### **ITEM FOR ENVIRONMENTAL COMMISSION AGENDA**

**NAME & NUMBER OF PROJECT:** 305 S. Congress Planned Unit Development, C814-89-0003.02

**REQUEST:** To amend the current PUD.

**STAFF RECOMMENDATION:** Current proposal is not considered environmentally superior and thus not recommended but would be with the following conditions.

Water Quality

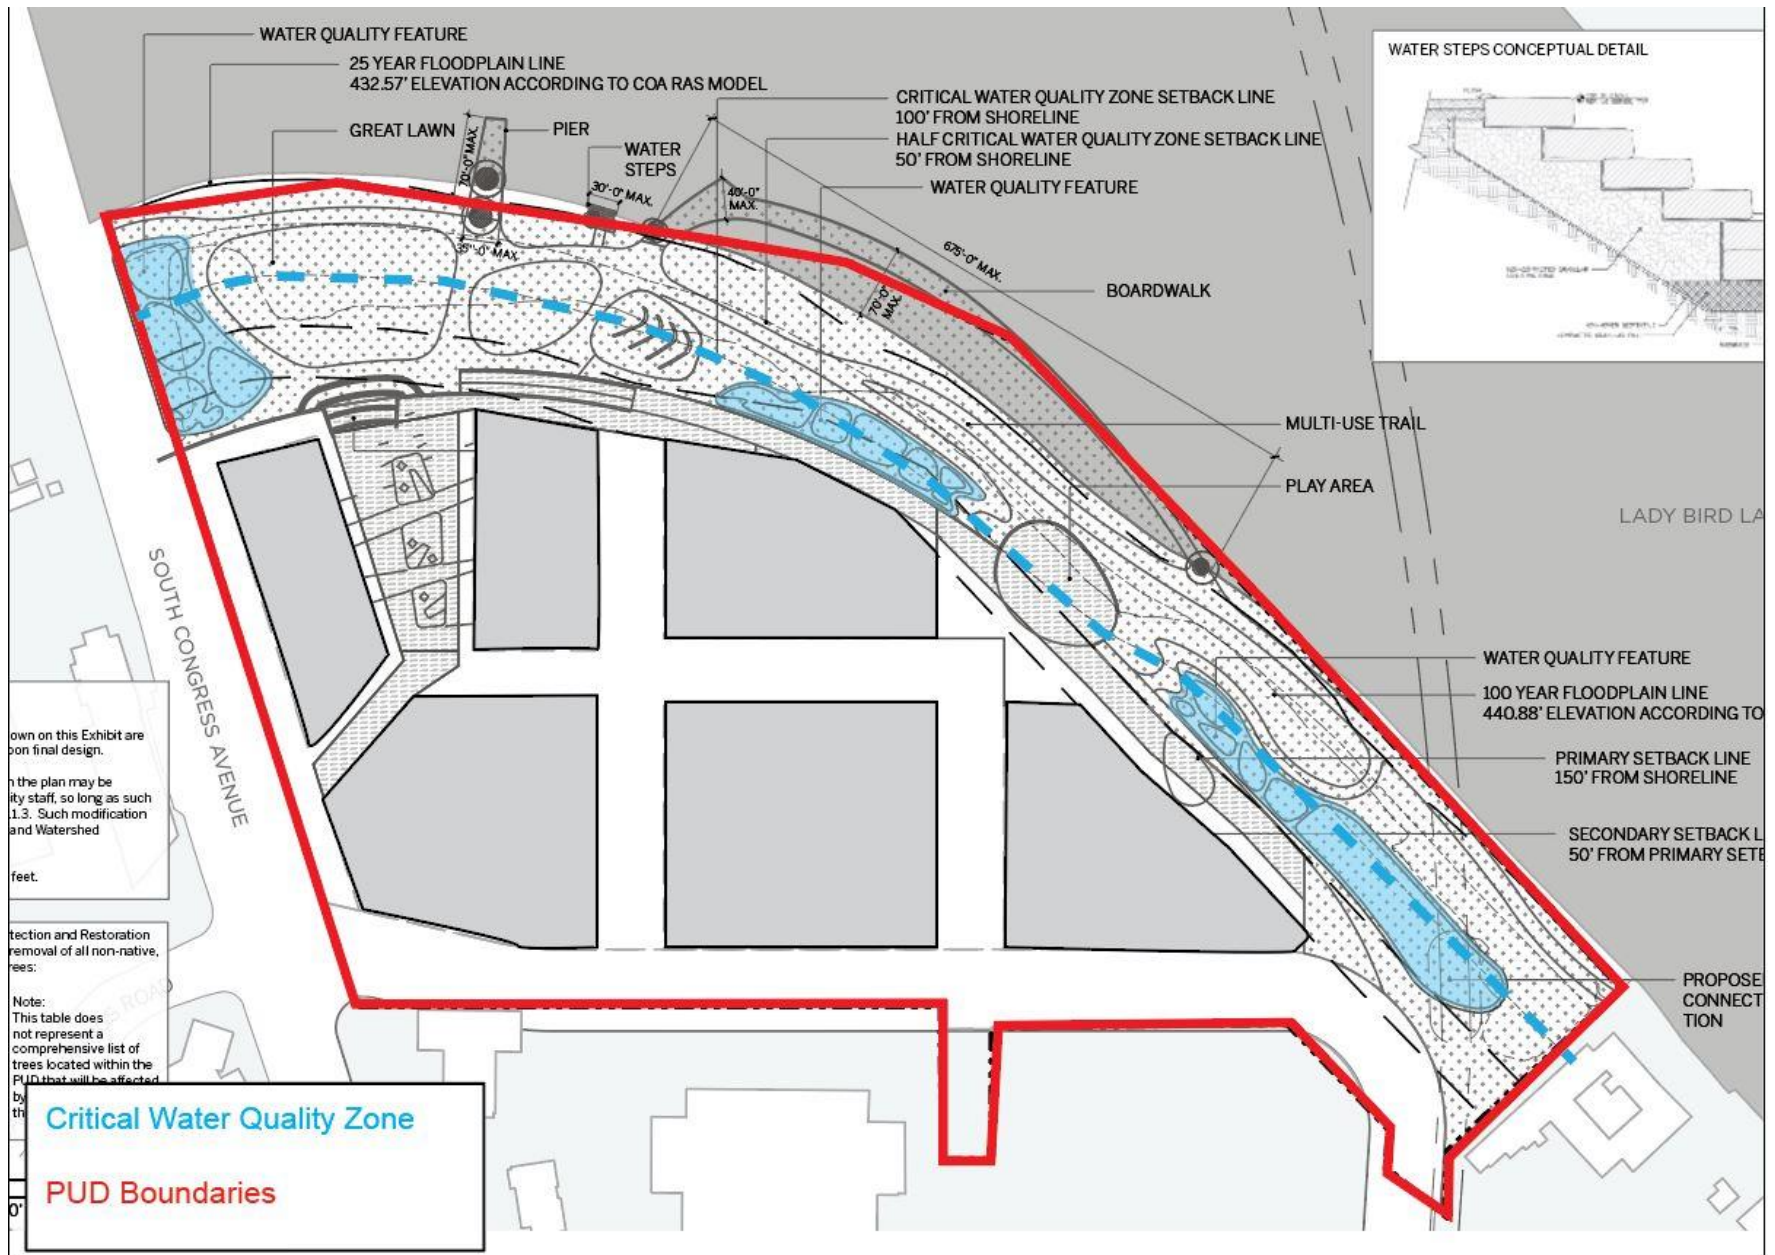
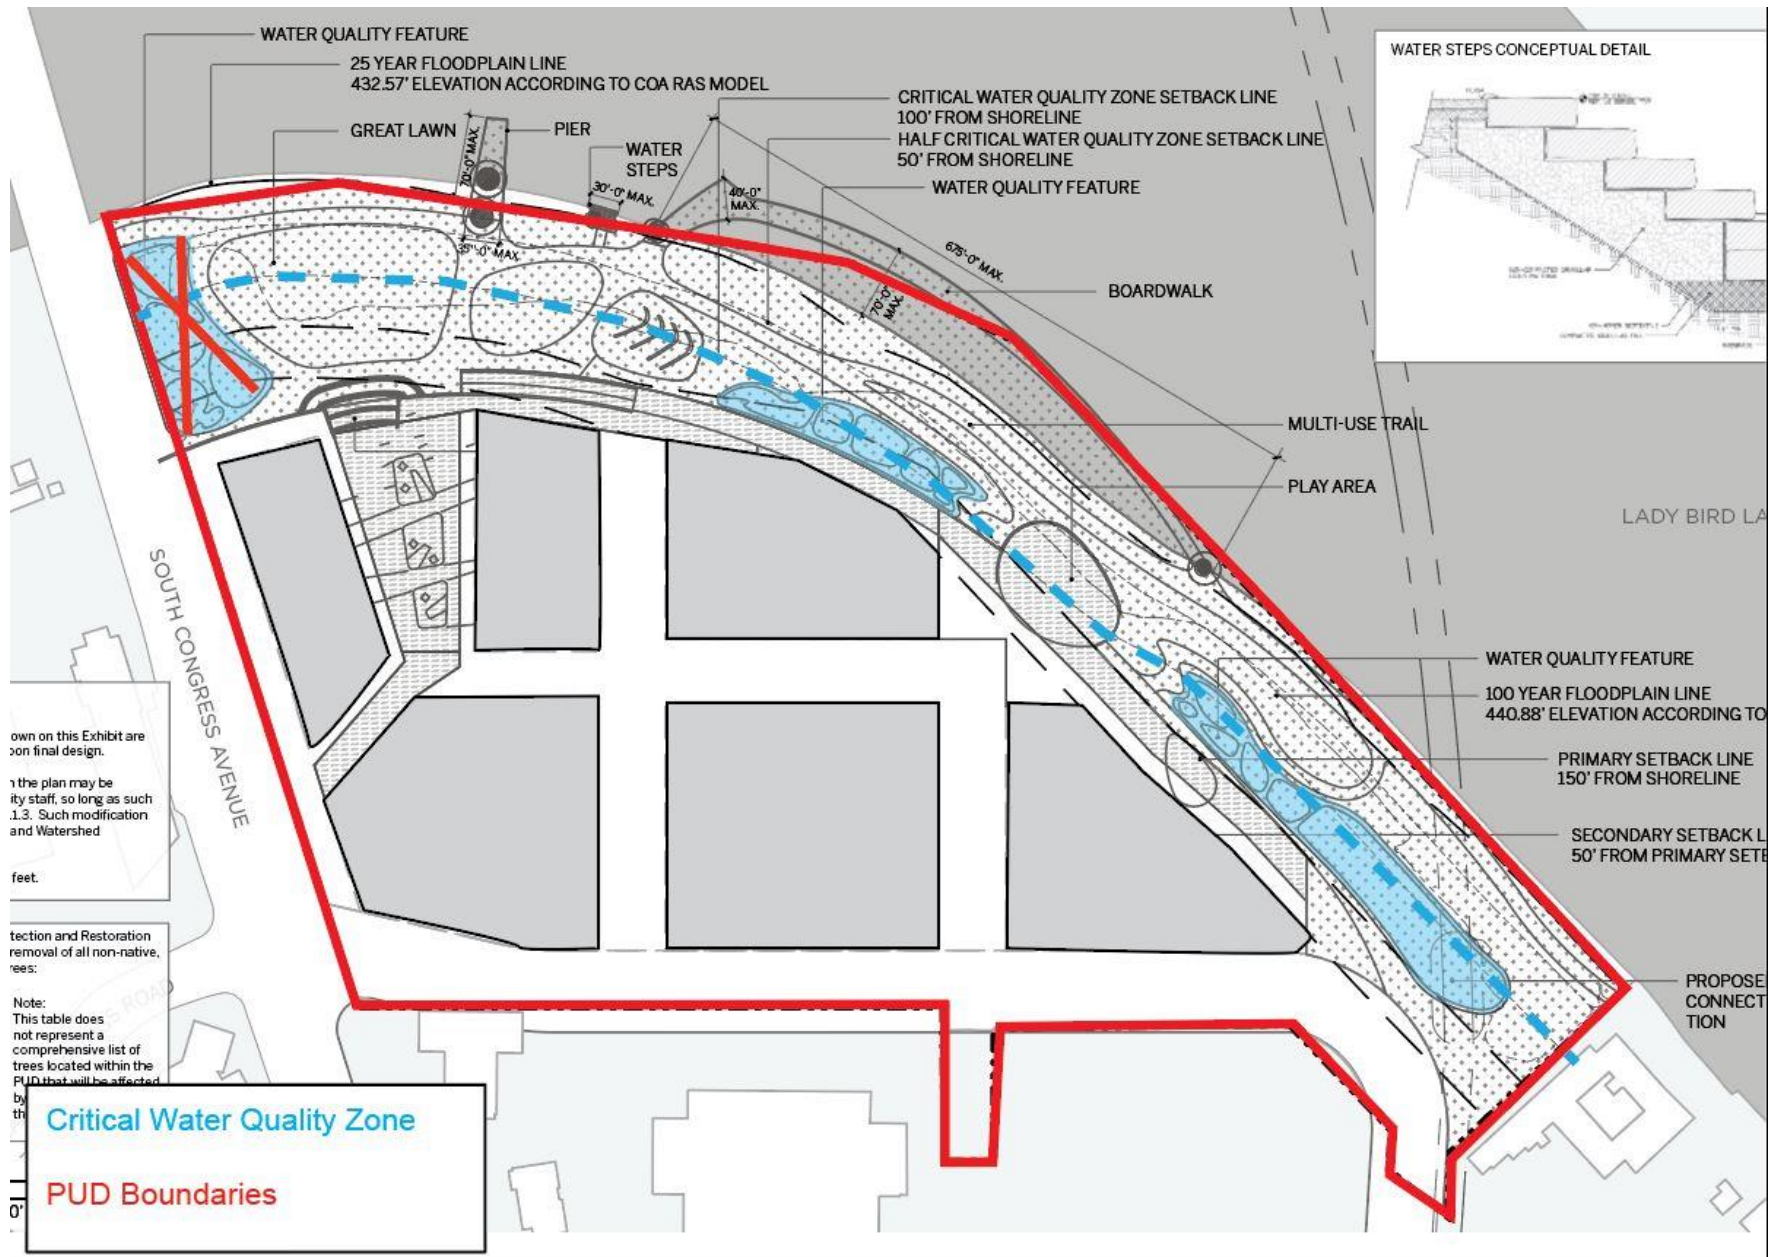
11. Proposed trees and shrubs shall be native or adaptive to Central Texas.
12. Provide water quality for all phases of the PUD project.
  - A. The project shall capture the maximum amount of stormwater within the project through cisterns and rain gardens located along the extension of Barton Springs Road.

- B. Water quality located within the CWQZ will utilize rain gardens that are integrated with the Hike and Bike trail.
13. Connect to and use Austin Water Utility reclaimed water for all non-potable water use within the project.

Proposed Trails

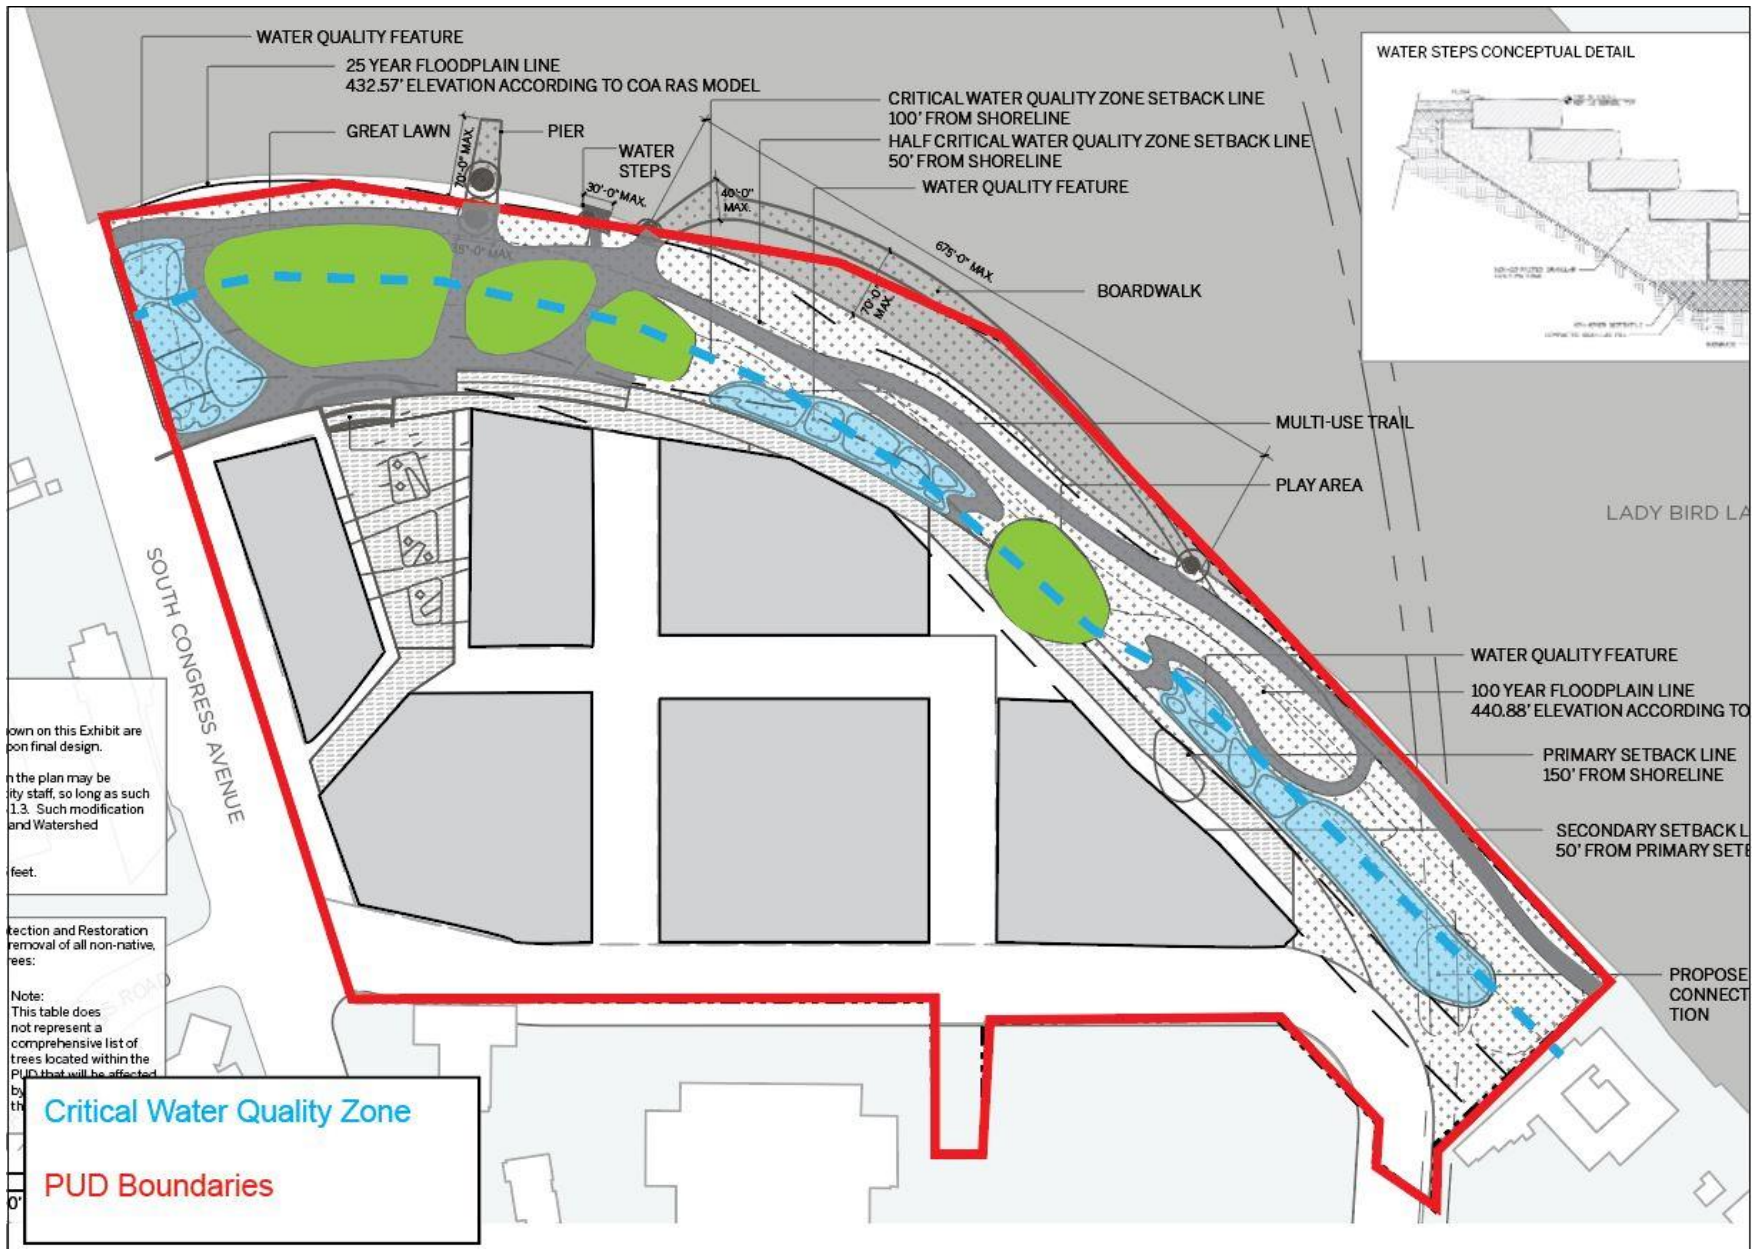
7. Relocate the trail a minimum of 25' from the crest of the slope along the shoreline except at approved shoreline access points and restore the area between the shoreline and trail with riparian or wetland vegetation. Protect the shoreline and vegetation with a split rail fence.

8. Eliminate redundant paths or trails within the critical water quality zone and reduce proposed impervious cover within the CWQZ to 5%, this number will include proposed concrete sidewalks.
